Access Compliance Report

(Curb Ramps)

Intersection ID: 6465	Main Street: PEACHTREE_RD	Cross Street: OAKDALE_RD	Location: SW
ADA ID: 39A68BBB5C7F	Ramp Type: Perp	Initial Pass/Fail: Fail	Overall Compliance: No
Severity Score: 8.75			
Codes/Mitigation Info/Possible Solution		Field Measurements/Component Compliance

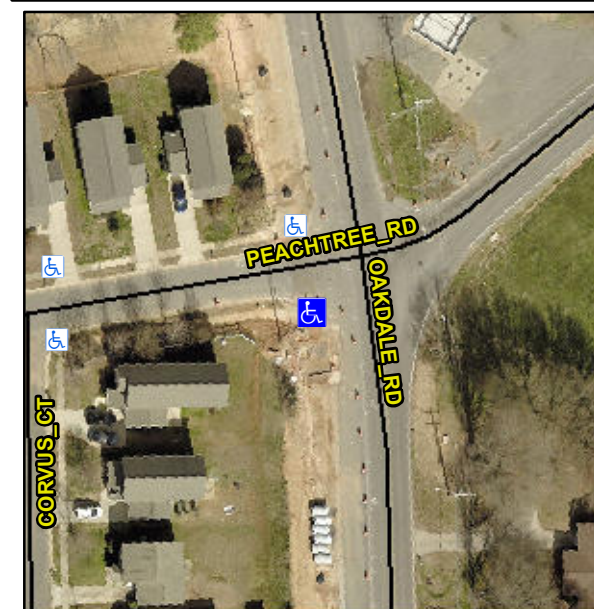
Not Found, R304.5.1

Compliance	Description	Data	Compliance	Description	Data
N/A	Ramp Length (in)	46.0	Yes	Ramp Slope (%)	5.7
No	Ramp Width (in)	41.5	Yes	Ramp XSlope (%)	0.7
N/A	Flare Type LT	N/A	N/A	Flare Type RT	N/A
N/A	Flare Slope LT (%)	N/A	N/A	Flare Slope RT (%)	N/A
N/A	Flare Traversable LT?	N/A	N/A	Flare Traversable RT?	N/A
N/A	Landing Length (in)	N/A	N/A	DWS Provided?	N/A
N/A	Landing Width (in)	N/A	N/A	DWS Contrast?	N/A
N/A	Landing Slope (%)	N/A	N/A	DWS Length (in)	N/A
N/A	Landing X Slope (%)	N/A	N/A	DWS Full Width?	N/A
N/A	Landing Curb? (Y/N)	N/A	N/A	DWS Offset (in)	N/A
N/A	Shared Landing?	N/A			
N/A	Gutter Ponding?	N/A	N/A	Gutter Slope (%)	N/A
N/A	Gutter Lip Ht (in)	N/A	N/A	Gutter X Slope (%)	N/A
N/A	Painted X Walk1?	No	N/A	Painted X Walk2?	N/A
	X Walk 1 Direction	To N		X Walk 2 Direction	N/A
N/A	X Walk 1 Width (in)	N/A	N/A	X Walk 2 Width (in)	N/A
	X Walk 1 Slope (%)	2.6		X Walk 2 Slope (%)	N/A
	X Walk 1 X Slope (%)	3.1		X Walk 2 X Slope (%)	N/A

Remove & Replace Entire Ramp.
